Field Service Bulletin No. 56

ADC Compact
Type 5145 / 100/101/140

Modification kits “C-clips Protection and Discharge Plate” and “Self-latching shaft at Feed Gate” applied to ADC Compact

printed in Germany 08 / 2002

1.1 Must Modification of C-clips Protection Plates

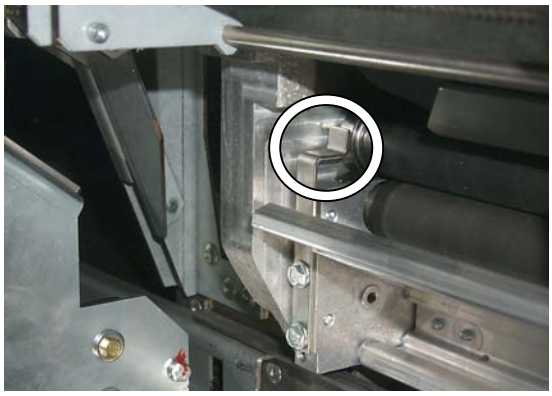
Incorrect reinsertion of scan rollers after cleaning causes broken c-clips and therefore a replacement of the complete slow scan unit is necessary. To avoid removal of scan rollers modification “C-clips Protection Plate” is introduced.

Protection plate has to be installed with the crank towards the scan roller. Modification kit includes four c-clips protection plates, for each side of both scan rollers.

1.2 Installation of Discharge Plate at Rotation / Cassette Unit

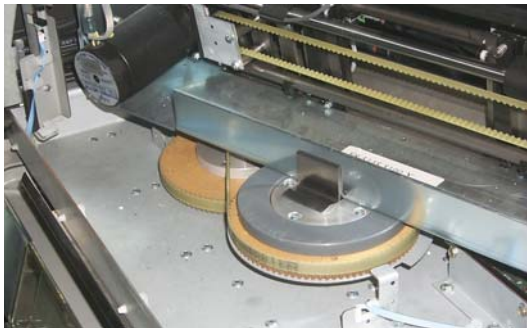
Discharge plate provides better grounding of the cassette unit and solves problems like, chip of cassette is not readable by the antenna.

Discharge plate has to be inserted in the middle of the rotation shaft.
